Administrative Approval Action

AA #3866 / S-2-18, Riverwalk Townhomes Subdivision
Transaction# 542014

REQUEST: Subdivision of a 48.08-acre tract zoned CM, R10 CU and NX-3 CU (Z-4-09), and within a SHOD-1 overlay district into a townhome development consisting of 272 residential lots and 13 common area lots for a total of 285 lots. This subdivision is to be recorded in three phases. This subdivision will utilize a wet pond to meet the zoning condition for extra detention. The wet pond and a TN offset buydown will be used to comply with stormwater quality.

Riverwalk Townes block perimeter

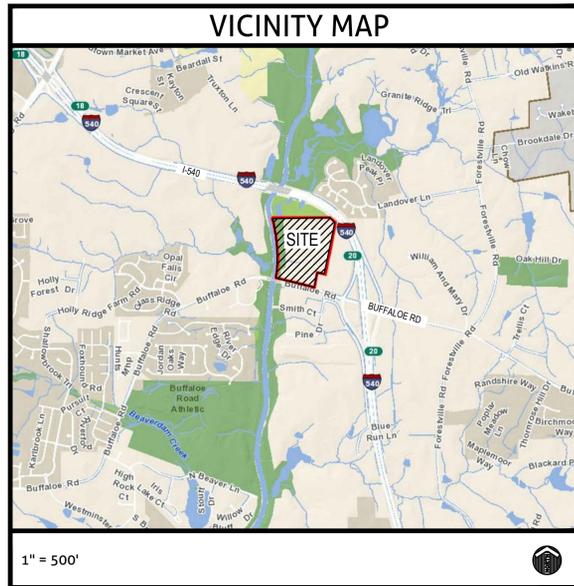
This subdivision is zoned NX-3, R-10 and Conservation Management which allows a maximum block perimeter of 2,500 LF - 3,000 LF. In mapping the block by following existing streets, the block perimeter measures 37,700 LF. There are several lengthy street extensions proposed on the City Street Plan Map that would reduce the existing block measurements. This site is limited in the number of public street connections, however there are 3 cross-access proposed stub streets / connections that are being provided with this plan. See the attached plan layout and block perimeter example.

1. Due to topographic and environmental conditions, a Design Adjustment has been approved waiving the block perimeter requirement (8.3).
